ATTACHMENT A

Updated: Attachment B Proposed Project Variances and Land Use Acreage Impacts Associated with the Proposed Project Variances

Updated: Table 5-1 Variances to the FERC Plan and Procedures for Modification MP44.6-45.1

ATTACHMENT C
Revised Alignment Sheet
Chain of Rocks Facility

SCALE PLAN: 1" = 200'	SCALE PROFILE H: 1" = 200'	SCALE PROFILE V: 1" = 200'
CLIENT APPROVAL	DATE	
PREPARED BY	DATE	
M M MOTT MACDONALD		REVISION
SCALE: 1" = 200'	DRAWING NO.: STLP-A-1007A	REVISION: 5

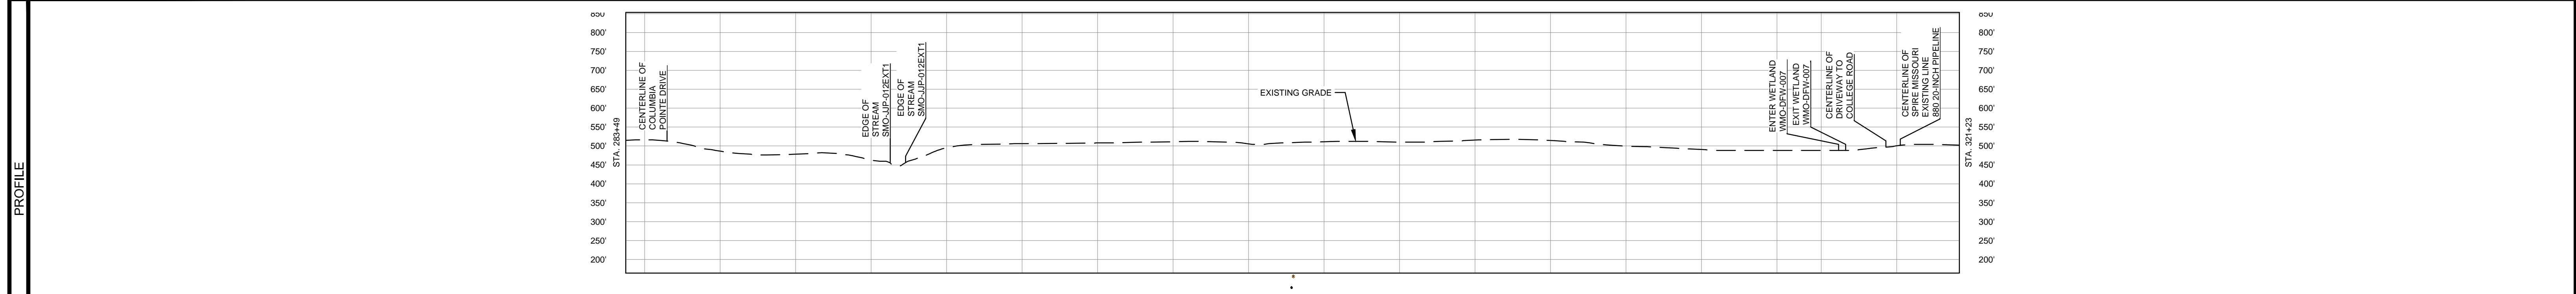
5.8R2-6.0R	Route modification/ Workspace modification up to 115' ±	Constructability	STLP-A-1007 (21)	MMID 6509	No	Agricultural, Wetland, Open Land, Forest, and Developed	Yes – No additional survey was required. Two streams avoided.	Supplemental information provided to USACE 12/15/2018 (Pending)	No eligible resources (Archaeology 1/26/2017; Addendum I 4/21/2017) / Yes	No additional survey was required; No species affected (10/26/2017)	No
